DEVELOPMENT APPLICATION ASSESSMENT REPORT

Application Number:	DA2019/0342
Responsible Officer:	Renee Ezzy
Land to be developed (Address):	Lot 11 DP 867302, 79 A Lauderdale Avenue FAIRLIGHT NSW 2094
Proposed Development:	Alterations and Additions to an existing residential building to create an attached dual occupancy and strata subdivision
Zoning:	Manly LEP2013 - Land zoned R1 General Residential
Development Permissible:	Yes
Existing Use Rights:	No
Consent Authority:	Northern Beaches Council
Delegation Level:	NBLPP
Land and Environment Court Action:	No
Owner:	Stepping Stone Custodian Pty Ltd
Applicant:	Stepping Stone Custodian Pty Ltd
Application Lodged:	09/04/2019
Integrated Development:	No
Designated Development:	No
State Reporting Category:	Residential - New second occupancy
Notified:	30/04/2019 to 14/05/2019
Advertised:	Not Advertised
Submissions Received:	13
Clause 4.6 Variation:	4.3 Height of buildings: 20% 4.4 Floor space ratio: 100%
Recommendation:	Refusal

Figure 2 - Carport roof identified on Second Floor Landscape Plan - LP04 Issue J (Source: mm+j architects)

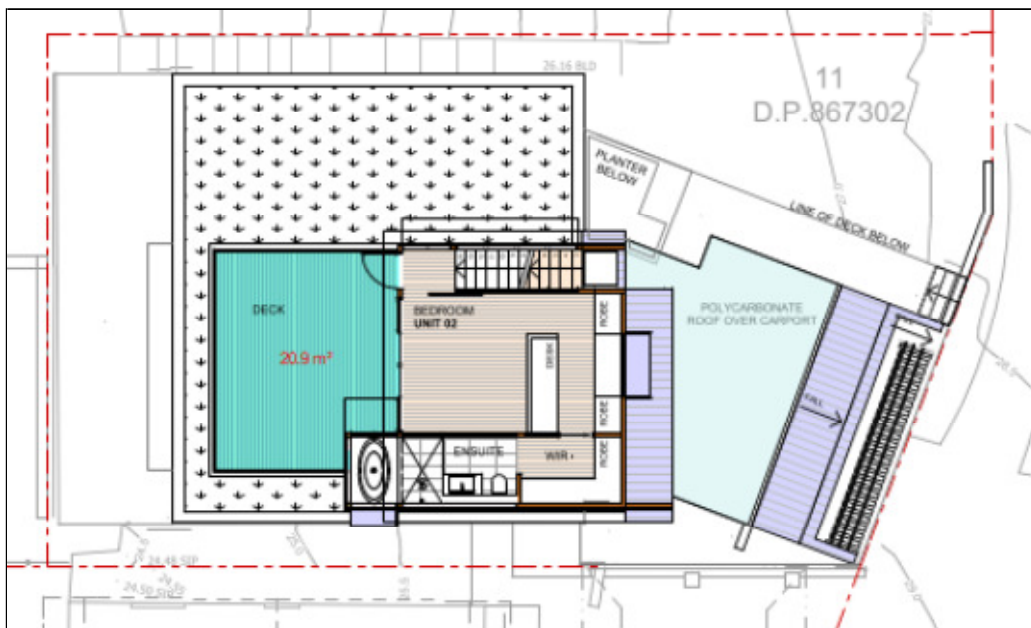
new polycarbonate carport roof structure that extends to the front boundary. This element of the proposal is questioned as it is inconsistently identified on the full set of plans lodged with this application, is not identified within the statement of environmental effects and is not included as part of the court consent issued on 11 December 2018 for DA326/20016.

As the details of a carport structure within the front setback of the site are not completely represented, it cannot be concluded that this aspect of the proposal maintains and enhances the streetscape. This structure is not supported.

Figure 3 - Second Floor Plan - DA17 Issue L (Source: mm+j architects)

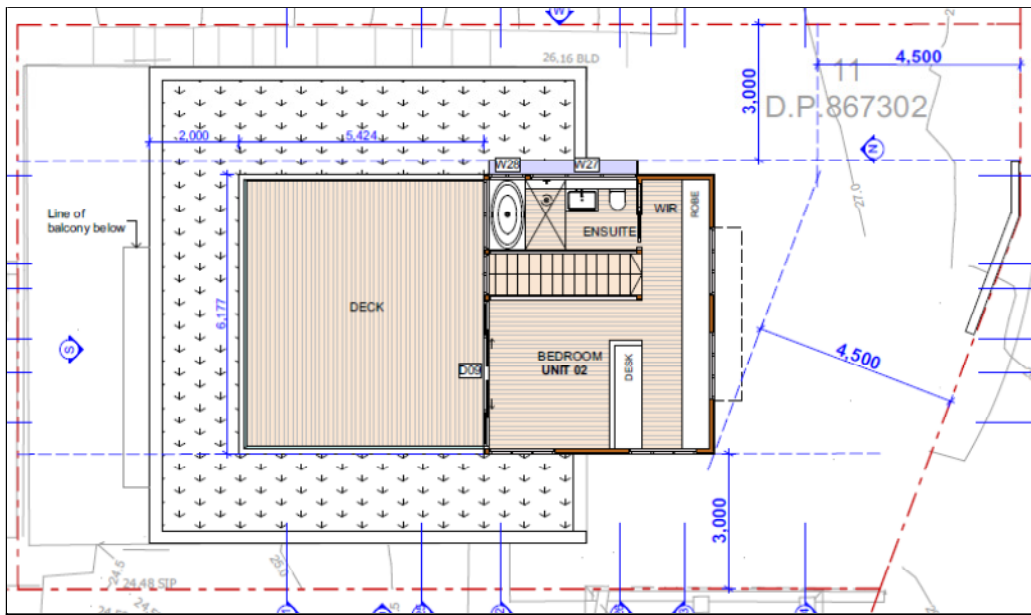
Privacy concerns are raised by the owners of the property to the east of the site, No. 77 Lauderdale Avenue Fairlight. Specifically, the areas of concern include the east facing windows at second floor level. These windows adjoin a bedroom and walk-in-robe/ desk area. While these windows are setback 3.0m on the second floor plan DA17, other plans within the set show this facade with only a 1.3m setback.

While the siting of the new second floor level in the centre of the building has merit notwithstanding the non-compliance with the setbacks required, the inconsistencies of the location of these works across the plans is unacceptable and cannot be supported.
